Westinghouse
Electric Corporation

DCP/NRC1343
NSD-NRC-98-5667
Docket No.: 52-003

SUBJECT: NRC REQUEST FOR ADDITIONAL INFORMATION 640.155 REV. 1

RAI: 640.155(R1) (OITS 6055)

Figure 640.155(R1)-1 Steel-Jacketed Concrete Form with Airtight Boundary

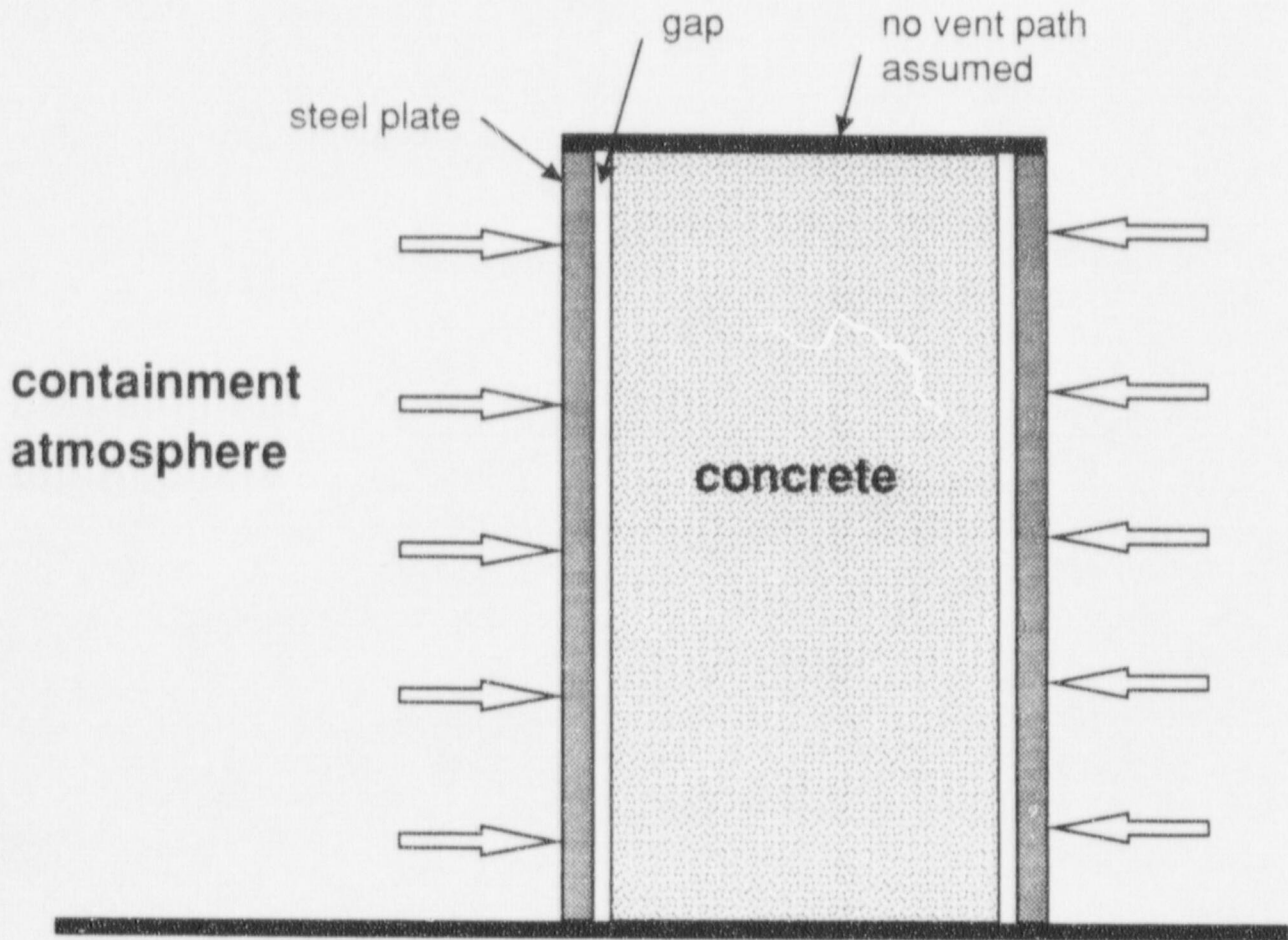
It is our assessment that the steel-jacketed concrete air gap under normal operation is zero, the concrete is likely in contact with the steel walls. For the staff to conclude that your analysis with the 20 mil gap, as used in the WGOTHIC evaluation model, is conservative, please address the following:

Assuming that the initial air gap is zero, for the limiting LOCA demonstrate that the heat transfer into the concrete through the initial contact with the wall and through the headed studs and other steel structures embedded in the concrete (attached to the walls) will not result in vaporization of moisture in the concrete sufficient to pressurize the structure such that the resulting loading on the steel wall would result in an average gap in excess of 20 mils as a result of the accident. The containment pressure can be considered in determining the overall movement of the steel walls in evaluating the gap dimension.

Concrete walls in the AP600 containment are lined with either carbon or stainless steel plates. The plates are the form for placement of the concrete. In many cases the concrete wall is partially capped with a steel plate making it difficult for the free water in the concrete to escape during curing. During the curing process, the concrete shrinks leaving a gap between the steel and concrete which can fill with water that has escaped the concrete during the curing process. There is a concern that during a mass and energy release to containment event, the free water inside the form may be heated and vaporize, increasing the pressure within the steel form above the containment pressure. This pressure increase could potentially deform the liner plate and create a gap between the concrete and the steel greater than the maximum gap assumed in the AP600 DBA containment pressure analysis (See Figure 640.155(R1)-1). An evaluation of the AP600 LOCA and Steamline break cases was performed to determine the maximum postulated temperature of the free water within the assumed concrete/steel gap, and the resulting pressure within the steel-jacketed concrete. This evaluation conservatively assumed that the steel encasement was completely airtight, thus maximizing the pressure increase.

The limiting MSLB and LOCA SSAR analyses were used to determine the maximum gap temperature. For the purpose of this evaluation, it was assumed that the liquid within the gap reached the same temperature as the surface of the steel liner. Thus, the steam pressure in the gap would equal the saturation pressure at the prescribed temperature. This assumption is considered to be conservative since it ignores 1) the temperature gradient across the steel liner, 2) the heat capacity of the water in limiting the heatup of the water trapped in the gap, and 3) heat removal by the concrete. Thus, the temperature of the water is over-predicted. Walls in the CMT room and SG rooms were chosen since these walls are exposed to the mass and energy releases from either the postulated LOCA or Steamline break.

For the LOCA, the maximum wall temperature occurred in a SG room wall, and had a temperature of 270.09 F with a containment pressure of 59.02 psia @ 1000 seconds. This would result in a gap pressure of 58.61 psia, the sum of the saturation pressure associated with 270.09°F and the air partial pressure. Thus, the containment pressure of 59.02 psia is greater than the pressure within the steel-jacketed concrete and the net delta-P would push in on the steel liner plates.

A review of the AP600 LOCA and Steamline Break containment response calculations showed that the maximum steel lined concrete surface temperature was 270.09°F for the LOCA case. Assuming that the water in the gap between the steel and concrete could reach this maximum temperature, the maximum pressure within the steel-lined concrete would be 58.61 psia, at a time when the containment pressure is at 59.02 psia. Therefore, the force exerted on the steel liner would tend to push the liner closer to the concrete, in all cases. This evaluation demonstrates that the pressure developed within steel-jacketed concrete during either a postulated LOCA or steamline break event is not sufficient to develop a pressure differential with the containment atmosphere. Therefore, there is no impact on the assumed gap between the concrete and the steel liner plate.
